**26-305-LH MACON BIBB COUNTY RADIO SHOP
4520 KNIGHT ROAD
MACON, GEORIGIA
BTBB #2024-29**

ADDENDUM NUMBER ONE

MBC RADIO SHOP
4520 KNIGHT ROAD, MACON, GEORGIA

EX1.1

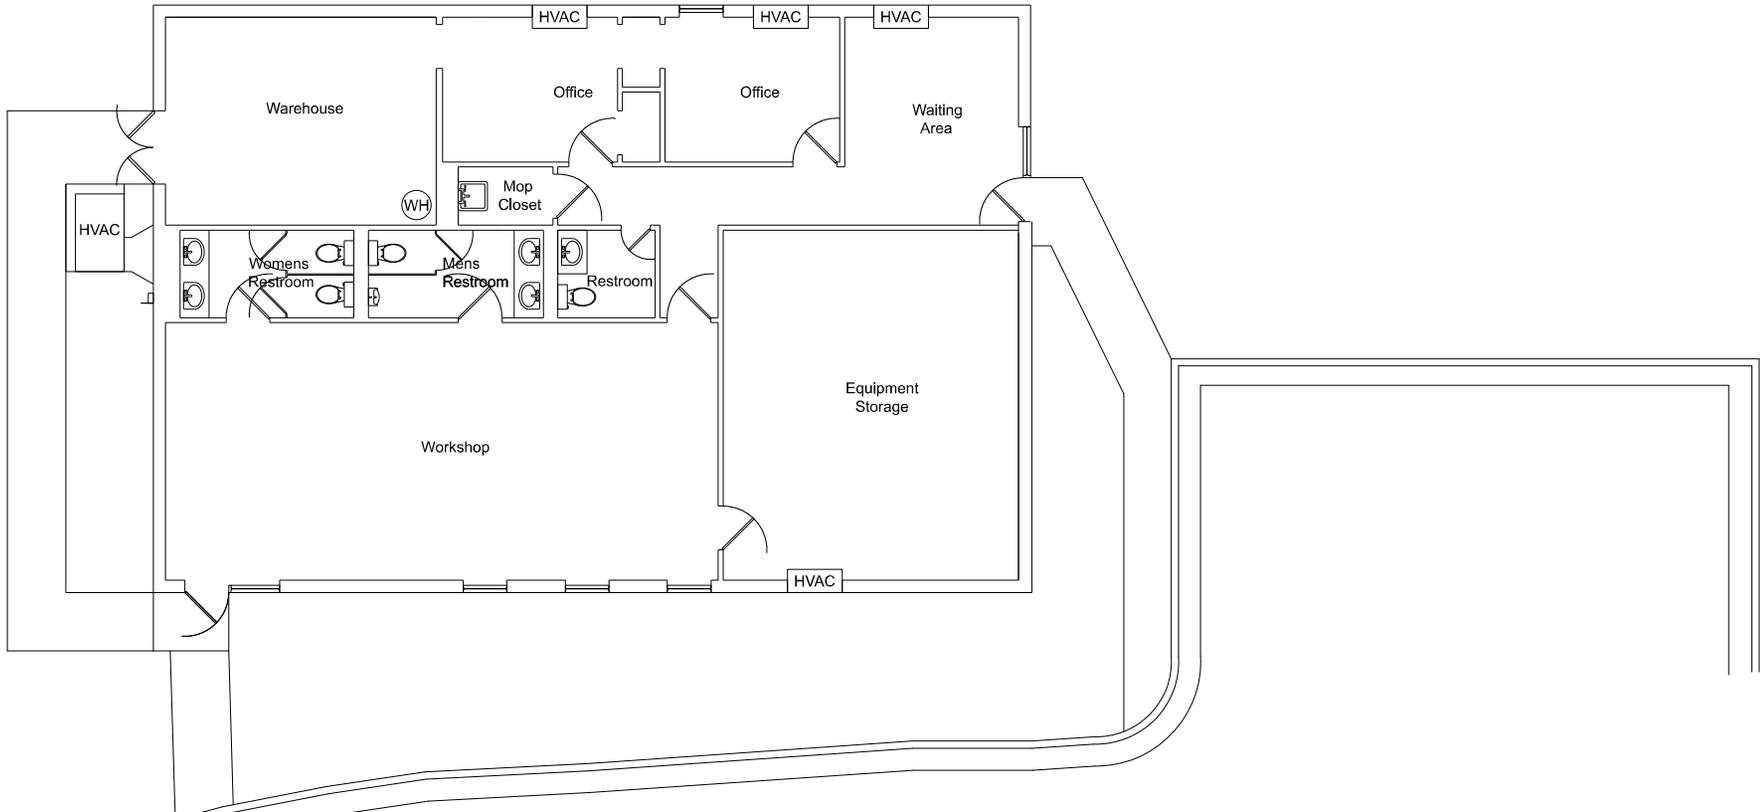
- A. The Contractor is responsible for all building and site demolition required to accomplish the new work shown on the plans.
 - 1. Disposal of Debris: Remove from the site all debris resulting from the demolition operations; burning of debris on site will not be permitted; place of disposal for demolished items shall be the Contractor's responsibility.
 - 2. Refer to the attached drawing, EX1.1 Existing Floor Plan, dated 10/24/25.
